**RE: RESPONSE TO INFORMATION REQUEST IN RELATION TO AN APPLICATION FOR MATERIAL CHANGE OF USE FOR FOUR (4) MULTIPLE DWELLINGS AND / OR SHORT-TERM ACCOMMODATION, SHOP, OFFICE, FOOD AND DRINK OUTLET (NOT PROVIDING A DRIVE-THROUGH FACILITY) AND HEALTH CARE SERVICES AND RECONFIGURATION OF A LOT (2 INTO 5 LOTS AND COMMON PROPERTY)**

### **30-32 Warner Street, Port Douglas Council Information Request Response**

30-32 WARNER STREET, PORT DOUGLAS		
CAR PARK & SITE ACCESS PLAN		
AUSTRALIAN STANDARD COMPLIANCE		
DRAWING NO.	227-002-SK02	REVISION 2

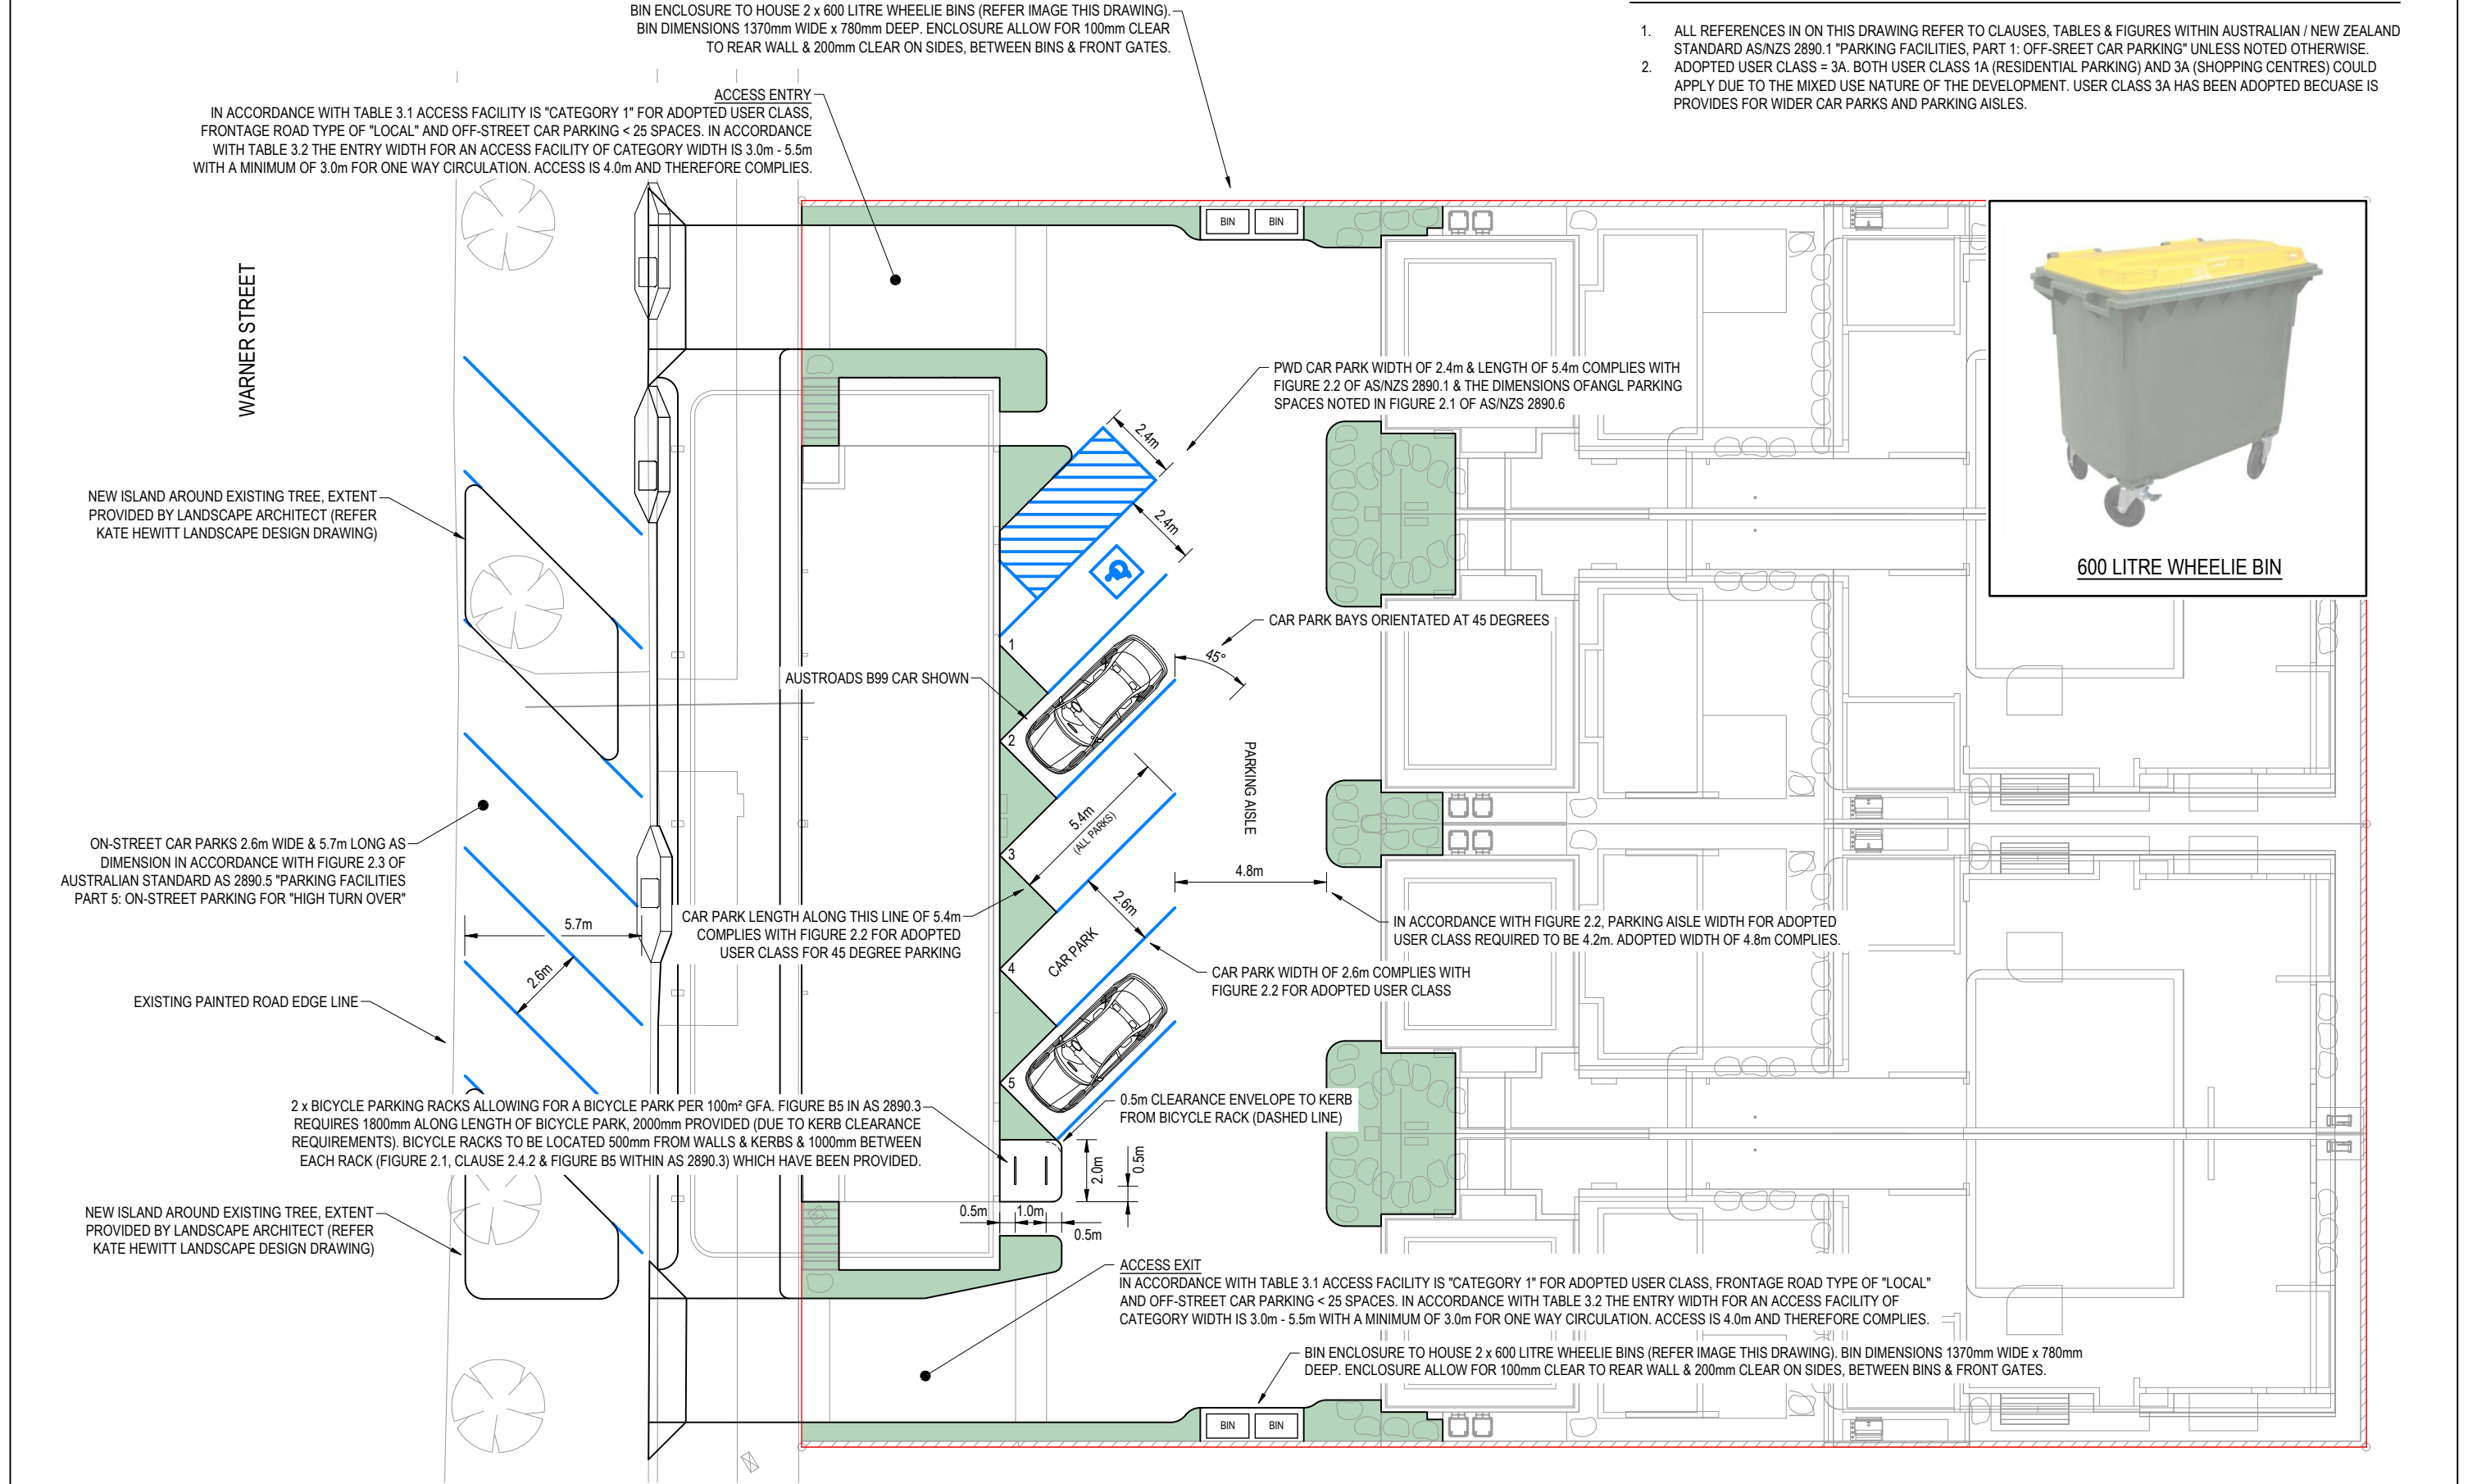
Please provide a plan that demonstrates compliance in accordance with the required Australian Standards. Please also compliment the design plan with a written statement prepared by a suitably qualified person that the car parking and access meet the Australian standards in respect to disability access and parking. Note that accessibility needs to be both from the street and from the disability car parking spaces to the entrance to the Commercial premises and the Short-term accommodation entries. Disability access may require a handrail and separate pedestrian access area marked on the ground if utilising the driveway area.

Please nominate on the site plan the bicycle parking as per the Planning Scheme requirements.

Please provide a plan detailing refuse collection facilities for the commercial tenancies.

Reference is made to CivilWalker Consulting Engineers' drawing 227-001-SK02 which provides detailed commentary on the proposed car parking arrangement referencing appropriate clauses, tables and figures within Australian / New Zealand Standard AS/NZS 2890.1 "Parking Facilities Part 1: Off-Street Car Parking", Australian Standard AS 2890.5 "Parking Facilities Part 5: On-Street Parking" and Australian / New Zealand Standard AS/NZS 2890.6 "Parking Facilities Part 6: Off-Street Parking for People with Disabilities".

As I suitably qualified person (being a Registered Professional Engineer of Queensland) I confirm that the car parking arrangements documented on drawing 227-002-SK02 Revision 1 (both on- and off-street) meet the relevant Australian Standards, being AS/NZS 2890.1 and AS 2890.5.

Reference is made to CivilWalker Consulting Engineers' drawing 227-001-SK02 which provides details of the proposed bicycle parking arrangement. Commentary is provided on the drawing detailing compliance with Australian Standard AS2890.3 "Parking Facilities Part 3: Bicycle Parking". The number of bicycle parks has been calculated in accordance with 1 park per 100m<sup>2</sup> of gross floor area.

Reference is made to CivilWalker Consulting Engineers' drawing 227-001-SK02 which details the proposed arrangement for commercial tenancy refuse facilities. A total of four (4) 600 litre wheelie bins are proposed with two separate enclosures housing two bins each. Details of the enclosure sizing are provided on drawing SK02.

30-32 WARNER STREET, PORT DOUGLAS	
ON-STREET WORKS	
GENERAL ARRANGEMENT	
DRAWING NO.	227-002-SK03
REVISION	2

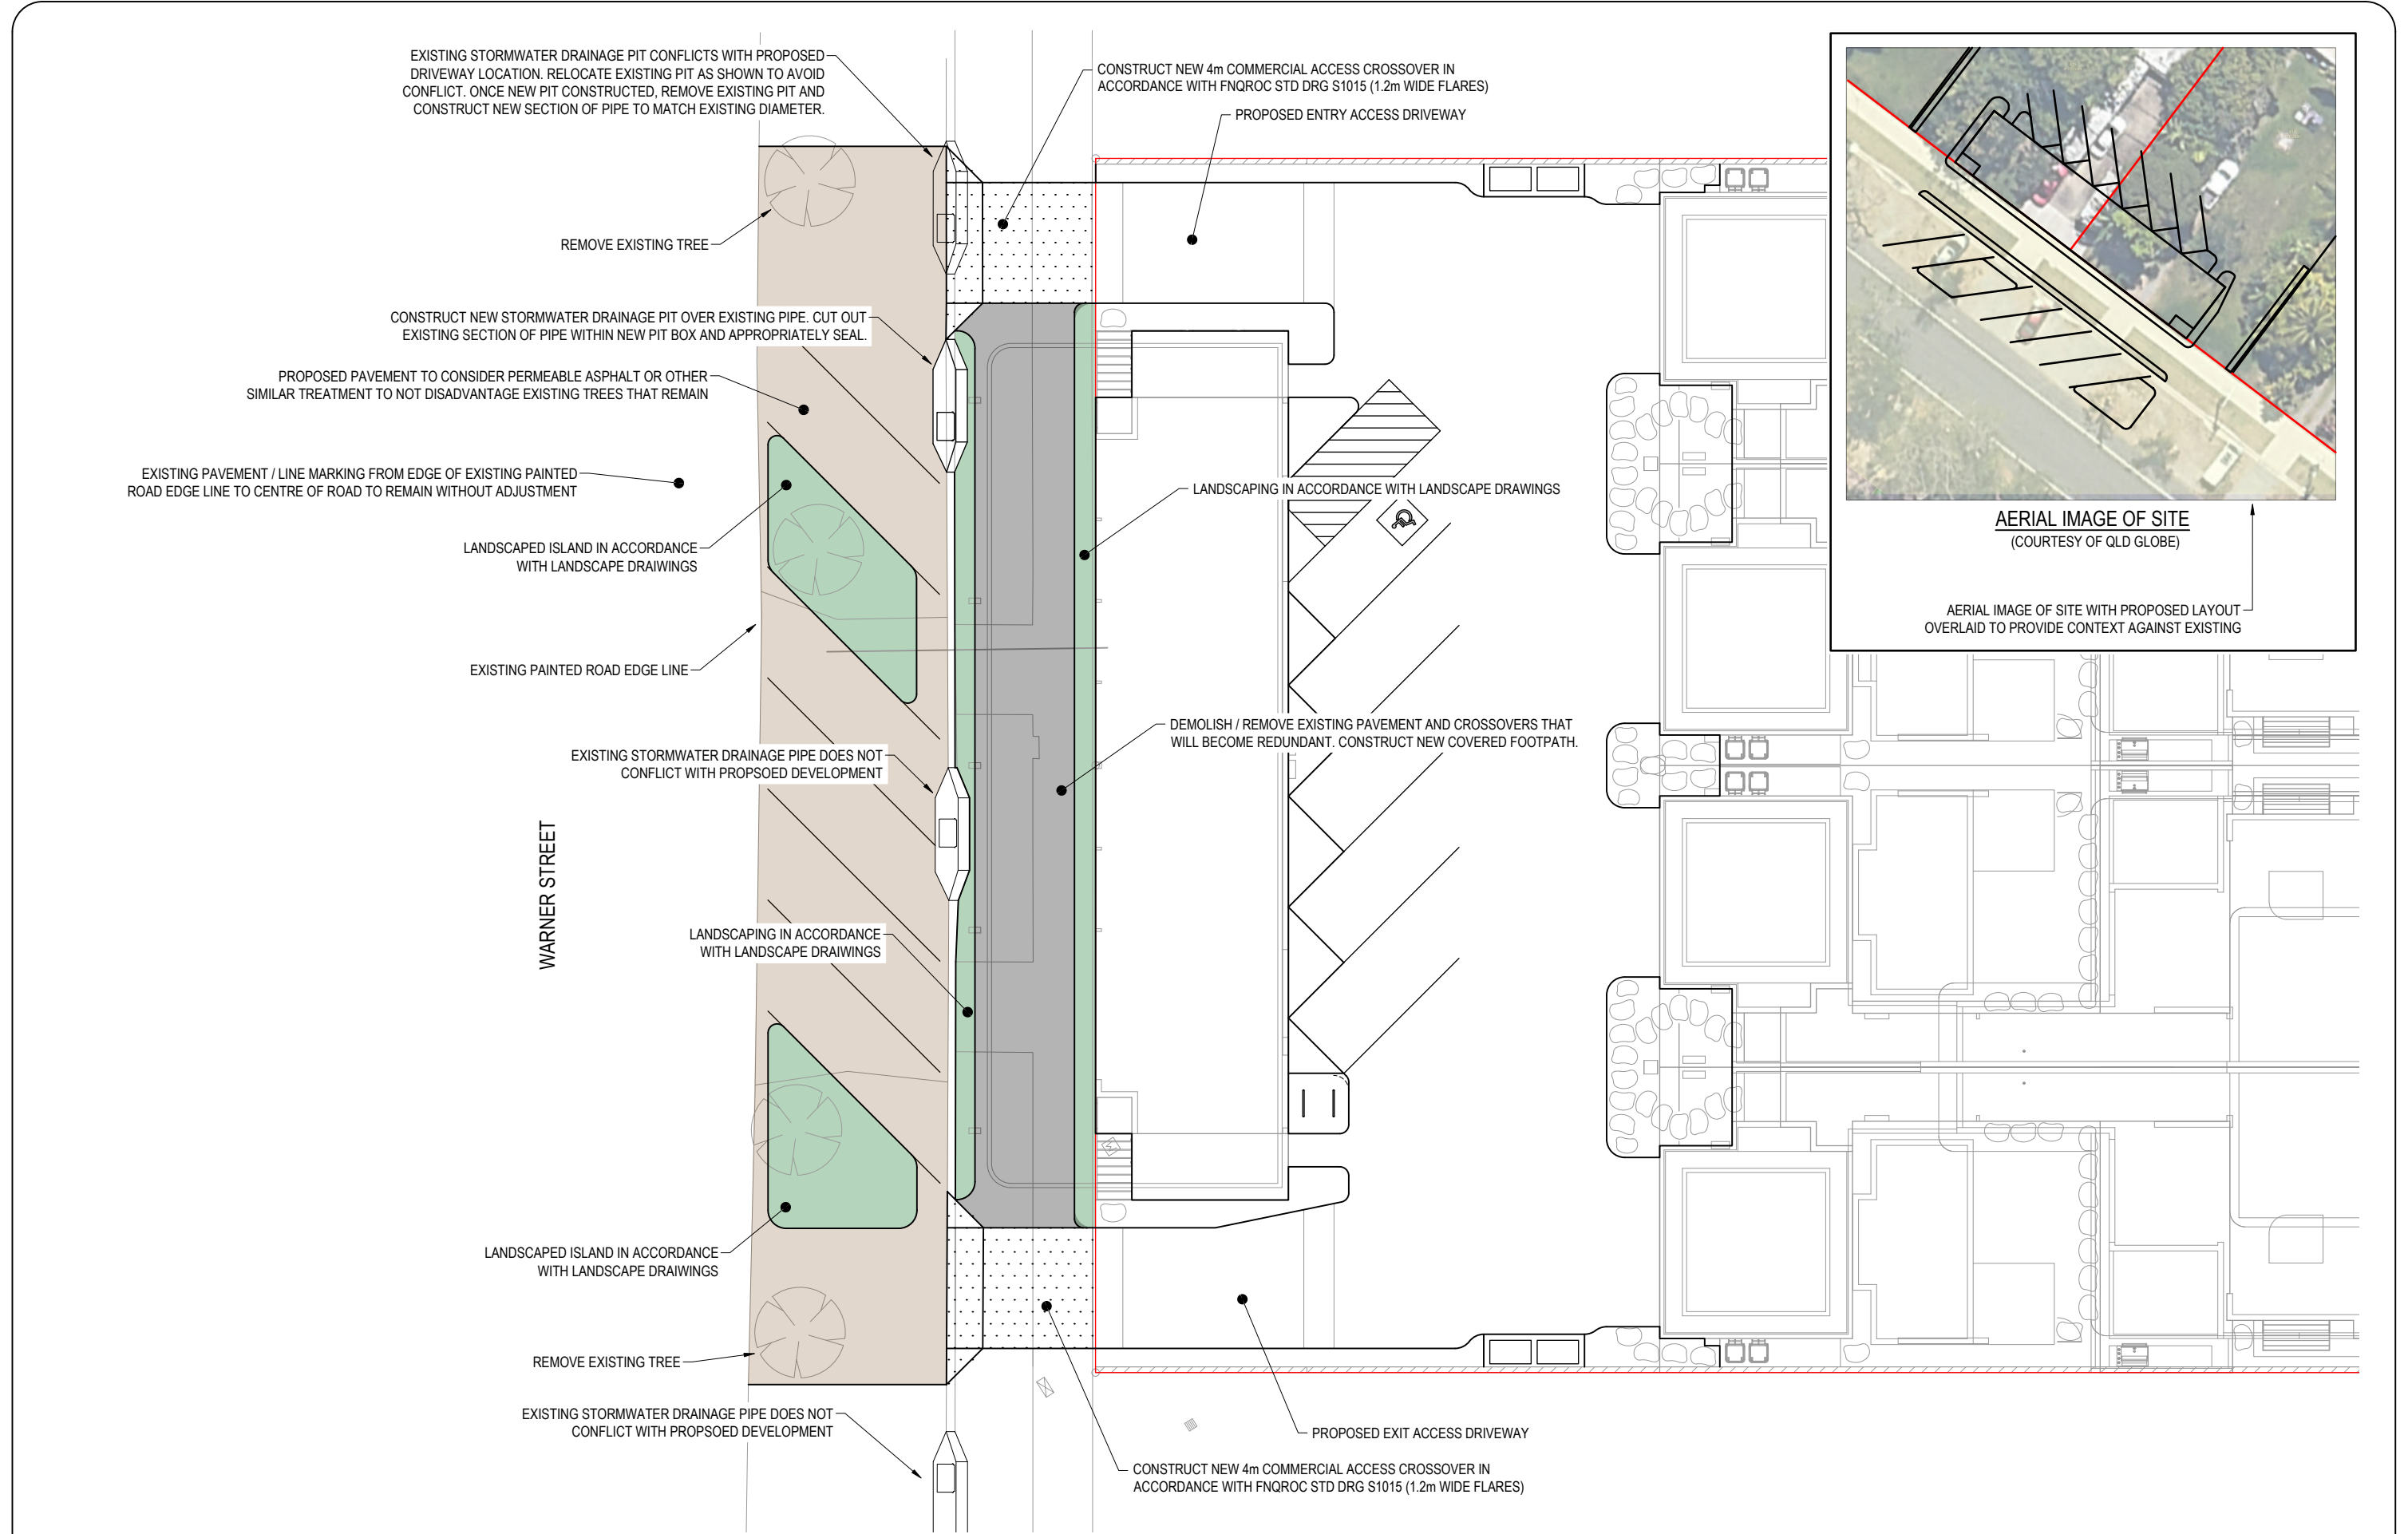
Please provide a sketch design of the proposed on-street works including on-street parking, footpath etc for the whole of the street frontage from the property boundary to the centre line of the road. The design needs to include any required relocation of stormwater inlet pits, inclusion of landscaped islands to protect the remaining street trees, sealed and line marked angle parking. The on-street works should reflect the design at the south-east corner of Grant and Warner Streets.

Reference is made to CivilWalker Consulting Engineers' drawing 227-001-SK02 which responds to this item.
